Type 0 Power Parameter Updates

Michael Paul

Edits Satisfy D2.1 Comments:
87, 88, 89, 90, 91

Compensation Elements

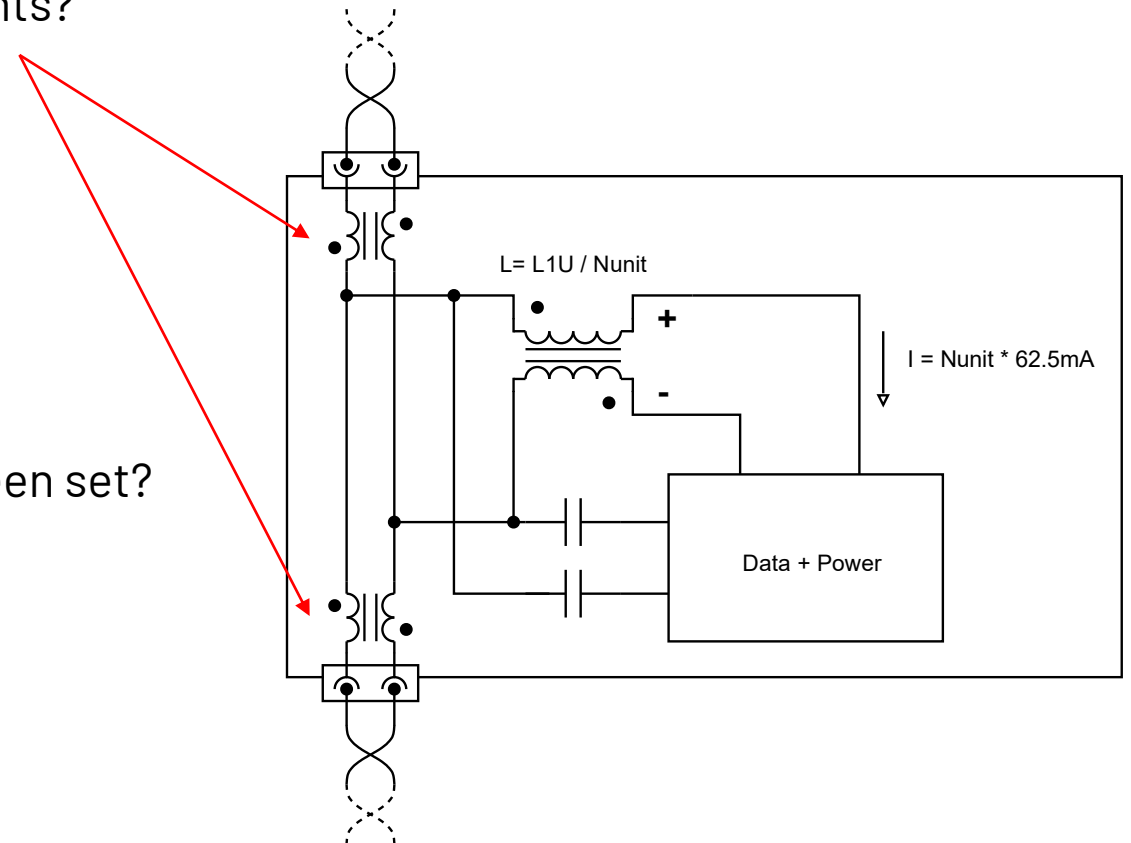
Low resistance / high current (>2A Isat) ~150nH coupled inductors are unique.

Not impossible to make, but not common yet

We need to set a target for vendors that pushes the limits, but does not push cost too hard

What is a good target resistance for these unique elements?

What is left in the budget after other parameters have been set?

189.2 Mixing segment

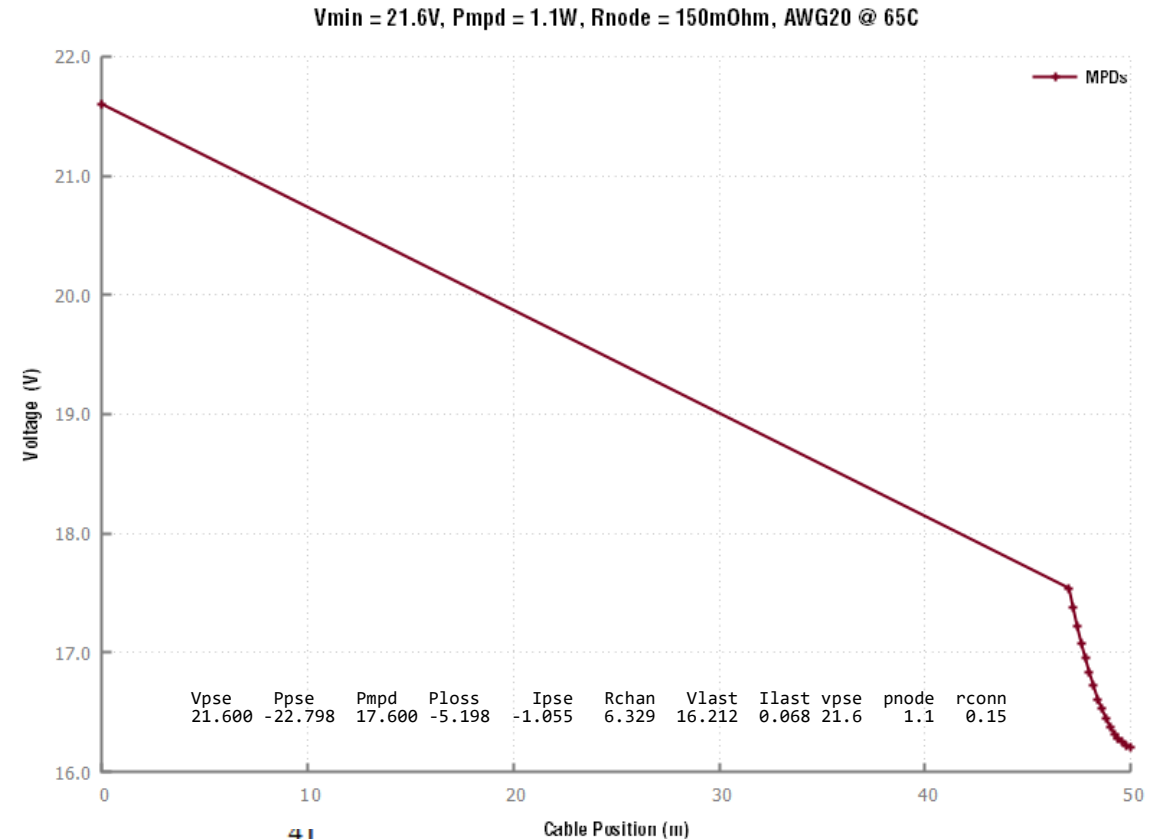
This resistance budget is based on supporting up to 17 in-line nodes (1 MPSE and 16 MPDs). Each DTE, including mated connectors and compensation components, adds up to 100 mΩ to the loop resistance.

Each DTE adds 150mΩ

Set resistance through each node to 150mΩ

Allocates ~75mΩ to connectors

Allocates ~75mΩ to compensators

Achieves other power deliver goals (Vmpse_type0_min, Pmpd_type0, #Nodes, 50m Reach)

This resistance budget is based on supporting up to 17 in-line nodes (1 MPSE and 16 MPDs). Each DTE, including mated connectors and compensation components, adds up to ~~100~~ mΩ to the loop resistance.

150
